HISTORIC AND DESIGN REVIEW COMMISSION

HDRC CASE NO: 2024-028
ADDRESS: 9800 AIRPORT BLVD
LEGAL DESCRIPTION: NCB 16435 BLK 1 LOT 6 S A INTERNATL AIRPORT UT-12
ZONING: R-5, Public Property
PUBLIC PROPERTY: Yes
CITY COUNCIL DIST.: 9
APPLICANT: Paul Bielamowicz/Page
OWNER: Javier Castro/CITY OF SAN ANTONIO
TYPE OF WORK: Construction of a ground loading facility
APPLICATION RECEIVED: January 19, 2024
60-DAY REVIEW: April 7, 2024
CASE MANAGER: Edward Hall

Historic and Design Review Commission
Pre-Submittal Consultation Report

REQUEST: Construction of a Ground Load Facility at San Antonio International Airport

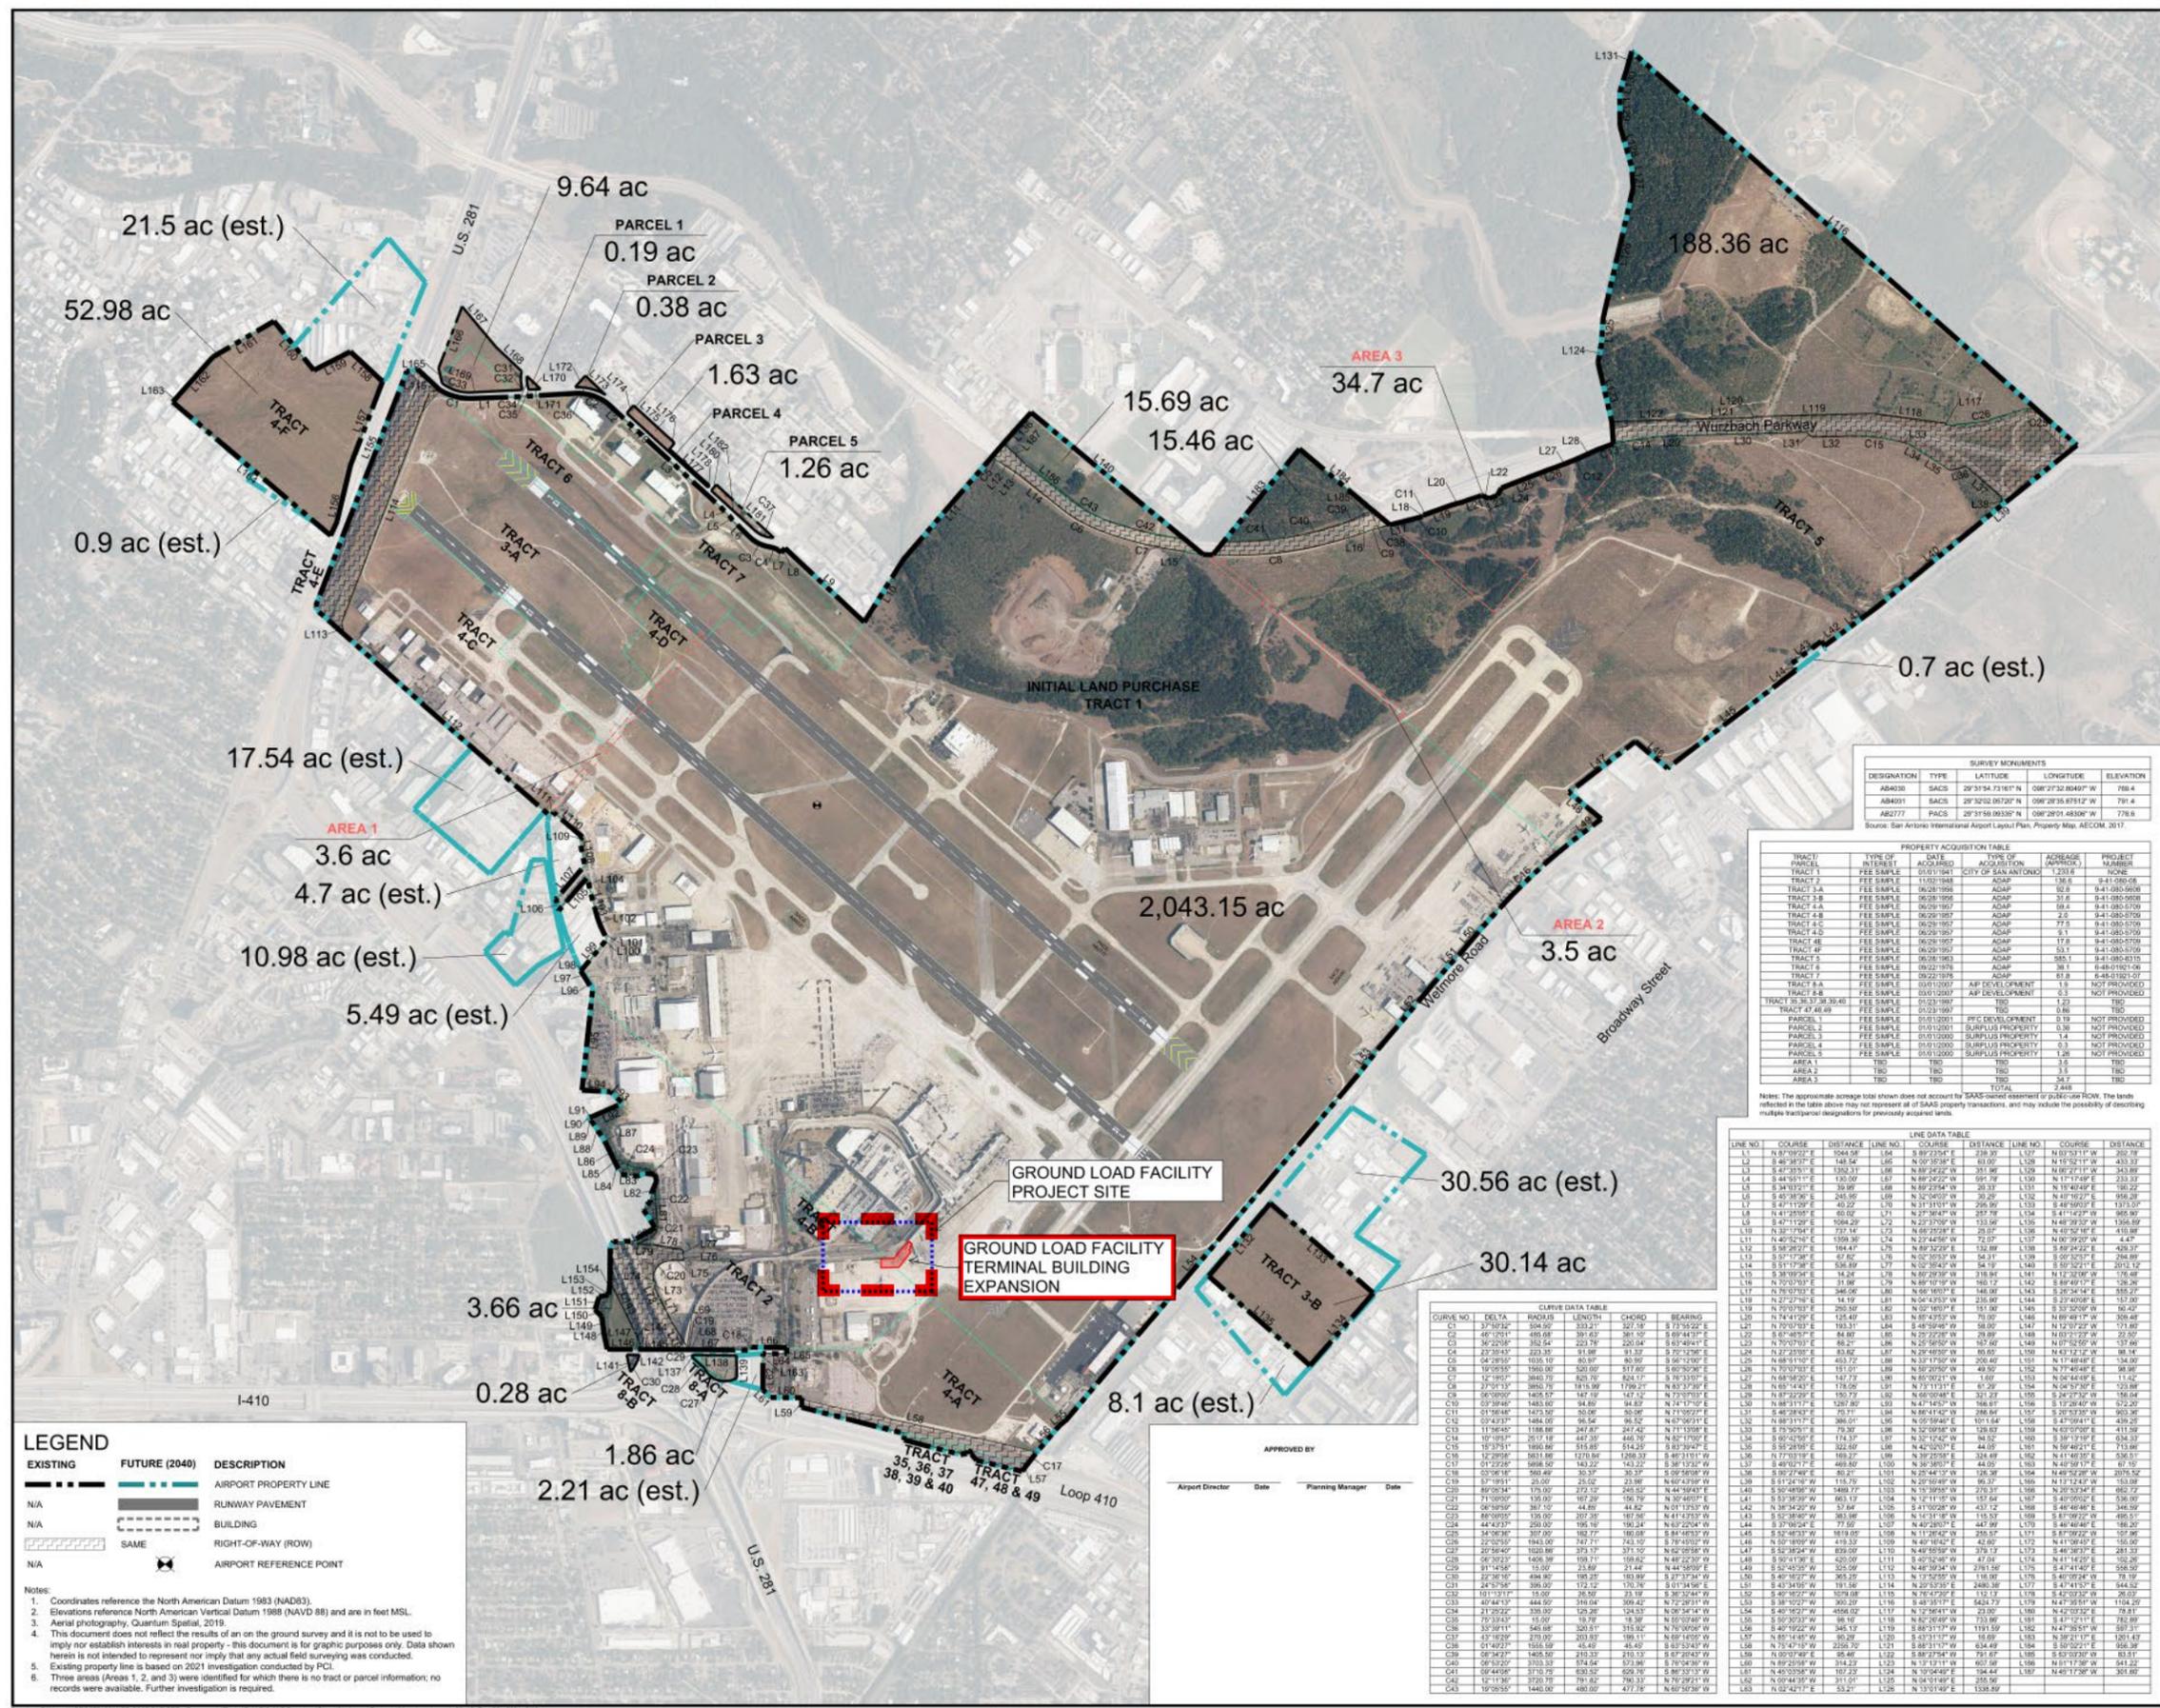
JF: Looking at terminal wall from the tarmac...The design does appear to look like a warehouse. Has the incorporation of punched windows high on the façade been explored (to break up flat planes and to let light into space). TS: Yes, this has been explored and could be incorporated still, pending budget. Budget does not currently include that.

LG: The color introduction is good as is the corner element. Is there any possibility to increase the height of the storefront; more solid wall above the glass gives a heavy appearance. TS: This has been explored; concerns over affordability.

JF: A lot of historic buildings feature a storefront with a horizontal awning with a transom above; can a design similar be explored? This could provide more light and break up the façade more.

LG: Feels that additional glazing should be incorporated into the design.

JF: The opportunity to break up the wall may present itself when the metal panel manufacturer becomes involved. Details in panels may provide patterns, shade and shadow.

JF: Thank you for the presentation. Hopefully budget and metal manufacturer will allow for some additional relief on long wall facing tarmac.

Our design team had a working group meeting with the HDRC and came away with two primary suggestions: find a way to get more daylight into the south-facing hold room areas and look for methods to enliven the long metal-panel clad wall which faces south. Our team studied solutions to both suggestions and held several meetings with our client to determine the best way forward. Regarding the suggestion to add more glazing to the south elevation, we studied several solutions including a clerestory window above the deep sun shade and increasing the height of the glazing beneath the sunshade by 20% (from 10' tall to 12' tall). We did a thorough sun study to check the impact of both those strategies and found that while the clerestory windows did provide interesting light with the space, sometimes that daylight and glare landed right in the seating groups within the hold room space – which would result in passenger discomfort or unoccupied seats. However, increasing the glass height by 20% provided more daylight than the original solution without unwanted glare. Our client directed us to increase the height and forgo the clerestory windows. An additional benefit to that strategy is that the long metal-panel clad wall height was also reduced by several feet. In addition to that, our team has worked with the contractor and metal panel supplier to devise a new metal-panel configuration featuring an alternating pattern. As a result, the elevation now features a lovely undulating texture that enlivens the entire south elevation and will catch sun and shadow in dynamic ways throughout the course of the day.
